METRO PLANNING COMMITTEE OF THE TOWN PLANNING BOARD

MPC Paper No. 14/16

**Submission for Compliance with
Approval Condition (b) and Approval Condition (l) of Application No. A/H4/94**

**Proposed Alteration and Modification Works to the Building
and External Façade for Cultural/Leisure/Retail/Food &
Beverage Uses/Open Space/Ancillary Support, for the Central Market
Revitalization Project in “Other Specified Uses” annotated
“Building with Historical and Architectural Interests Preserved for
Commercial, Cultural and/or Community Uses” Zone,
The Former Central Market, 80 Des Voeux Road Central,
Central, Hong Kong**

Fig 17. Interface with Existing building

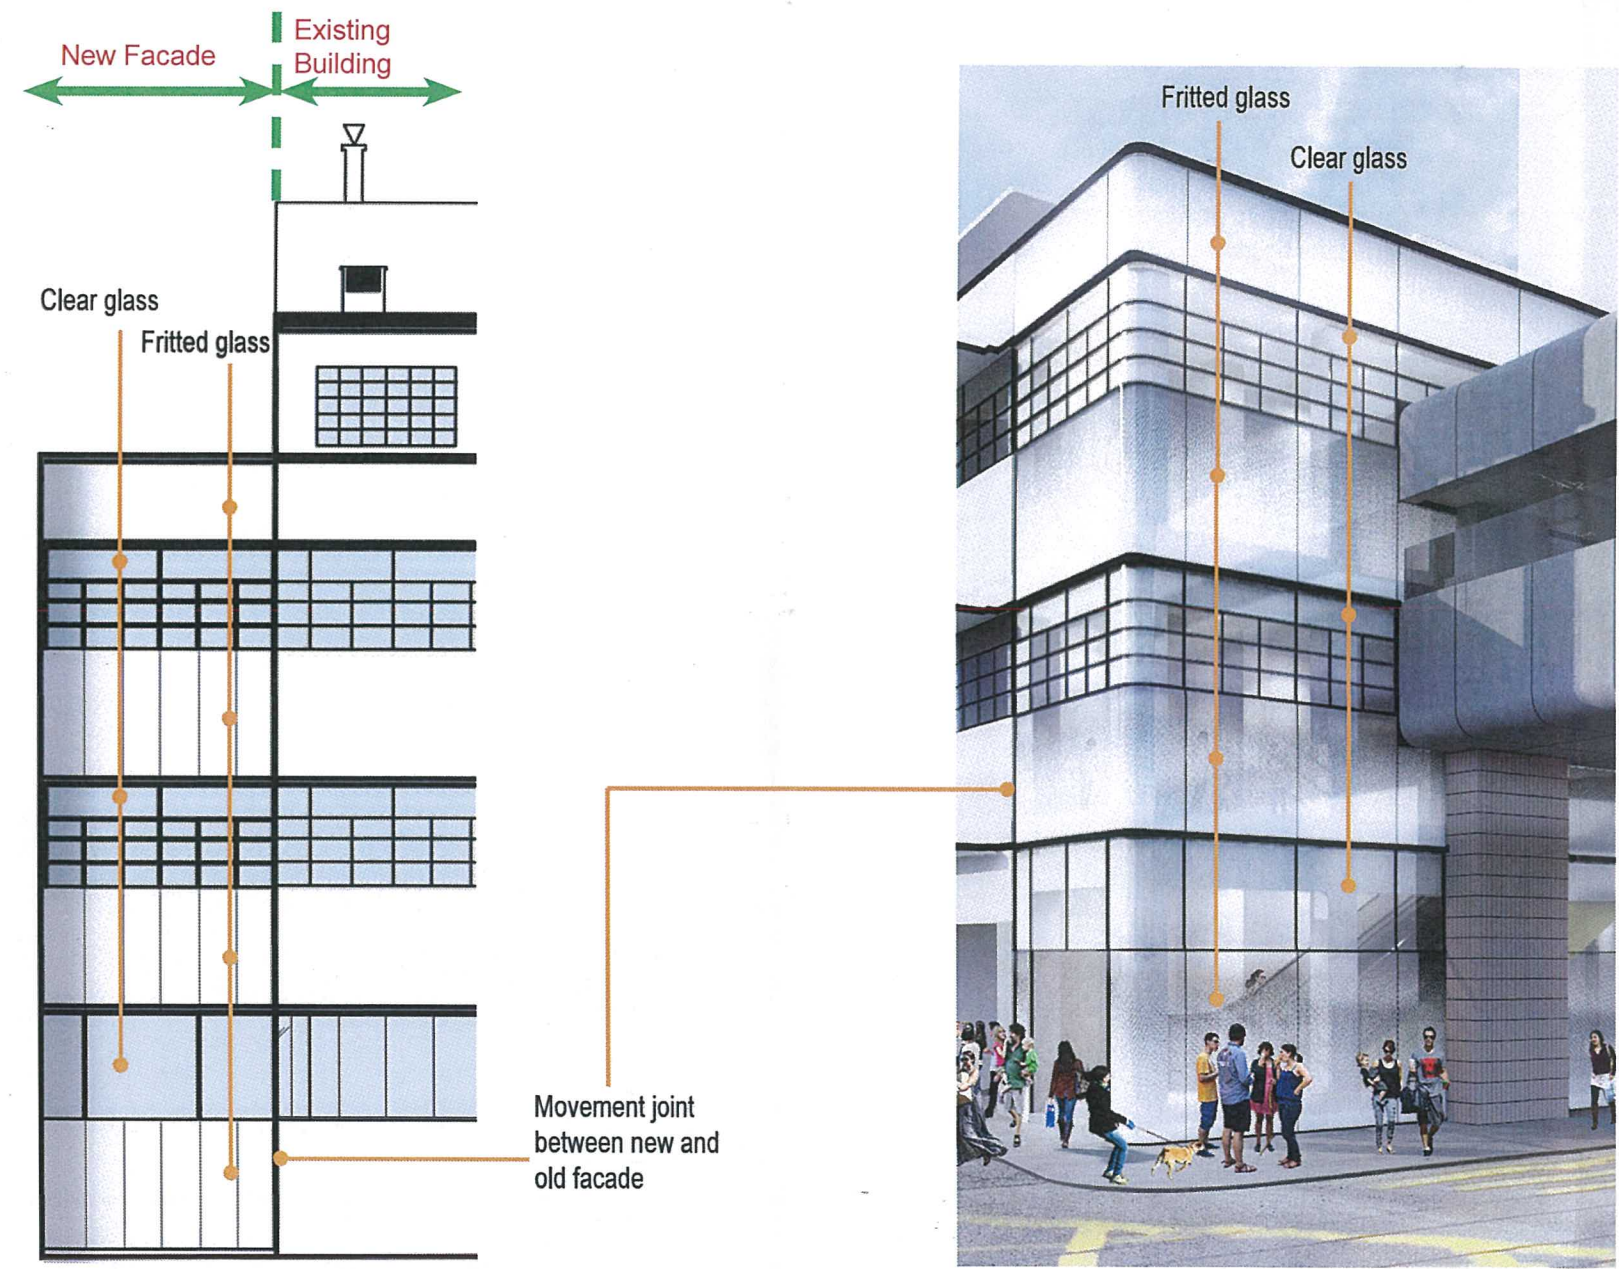
| | <p>the elements of the new facades, etc.</p> <p>We note that the applicant has tried to address the above concerns in the detailed design proposal for the new façade. However, due to the insufficient information provided by the applicant in this submission, the applicant is advised to provide further design details by means of section and elevation drawings to clearly illustrate the connection details between (a) the new and old facades; and (b) the existing footbridge and the new façade for AMO and TPB's further consideration.</p> | |

Besides, the submitted detailed design proposal has already included the details demonstrating the compatibility of interface between the new and old facades and the new façade and the existing footbridge, which should be adequate for TPB’s consideration and acceptance. Relevant government departments could later base on the approved proposal to ensure the further technical details be developed and implemented orderly through the following means as stipulated by TPB/ Planning Department:

1. According to approval condition (a), a Conservation Management Plan is required to be submitted to AMO for approval prior to commencement of major works. The details of the new facades, such as materials, colors and scales of elements will be duly addressed in the CMP for AMO’s consideration.
2. According to planning approval condition (c), the implementation of the detailed design proposal for the new façade facing DVRC to the satisfaction of AMO is required.
3. The plan submissions to BD will be circulated to concerned departments, such as PlanD and AMO for comments under the centralized processing. Changes or revisions, if any, in the façade design would be fully under control of relevant departments.

Nevertheless, ArchSD’s comments on window wall details, lighting design and cleaning methods are all noted and will be duly addressed upon the approval of building plans in the detailed design stage. AMO’s comments on the connection details are also noted and will be submitted upon the approval of building plans according to the means as mentioned above in the due course.

繪圖
DRAWING
AA - 1

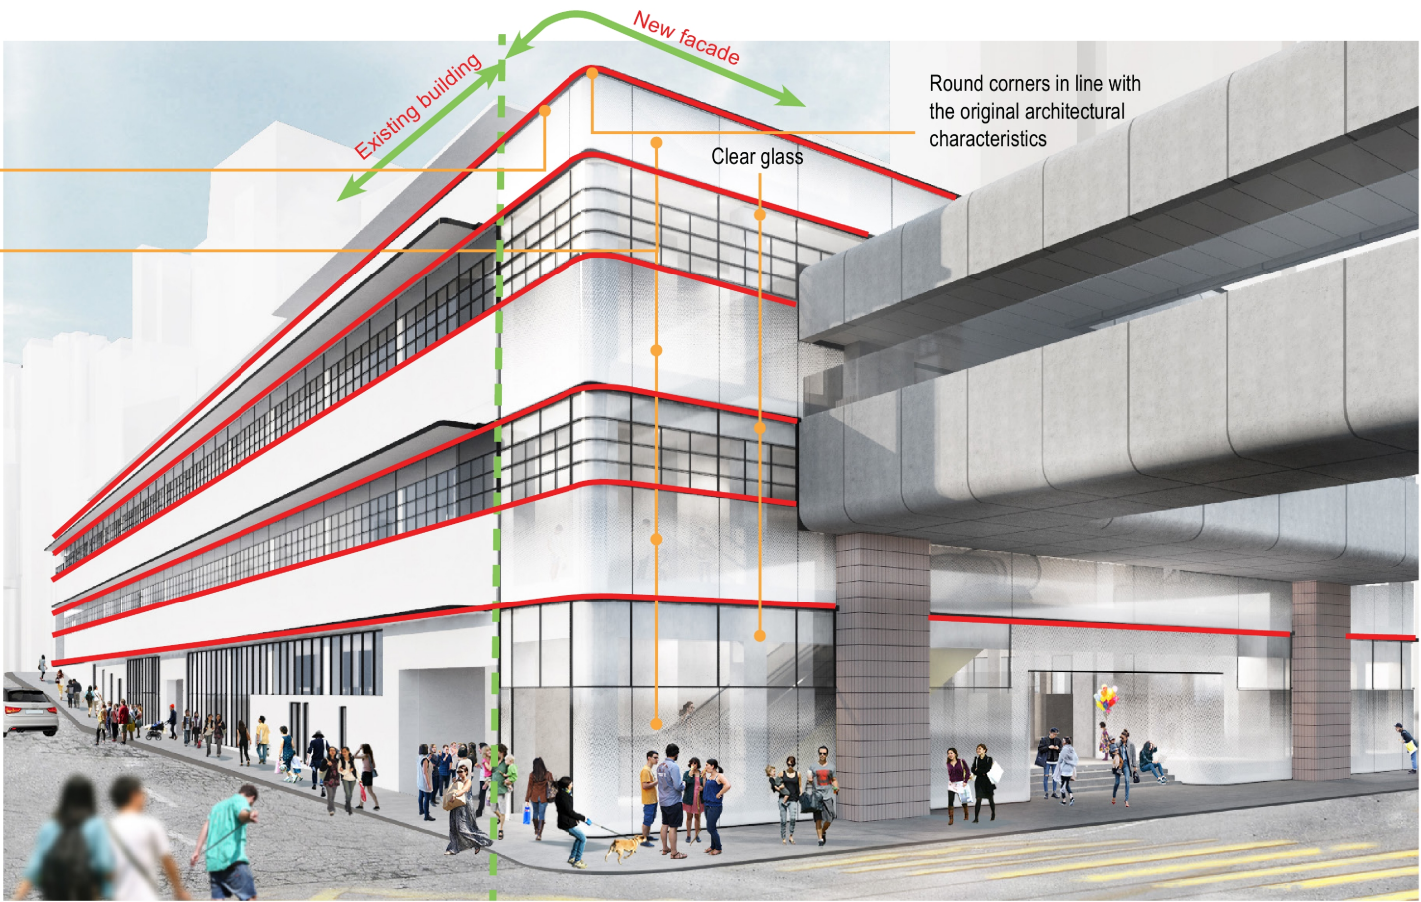
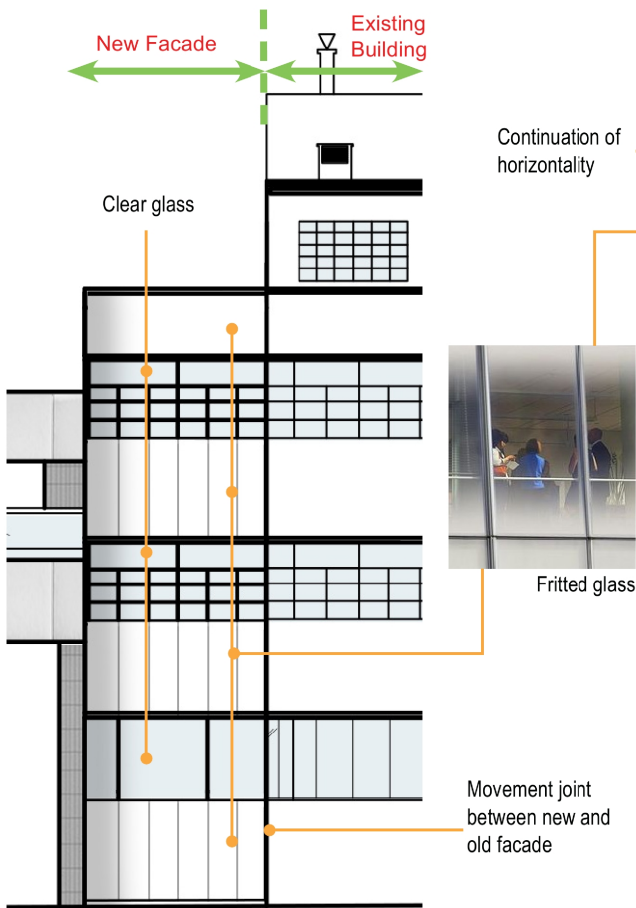
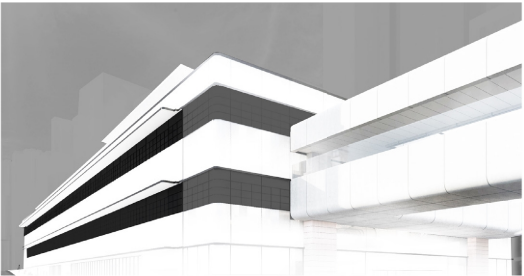
*Continuation of Horizontality at the New Structure Compatible with the Original Streamlined Modern Style (**Drawing AA-1**)*

繪圖
DRAWING
AA - 2

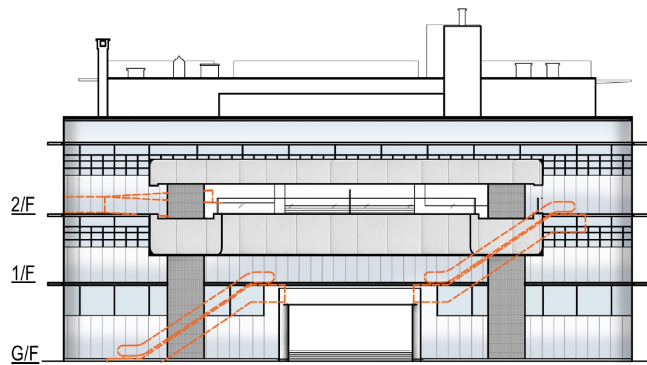
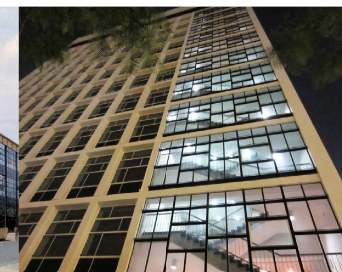
Enhancement of Visual Permeability and Accessibility (Drawing AA-2)
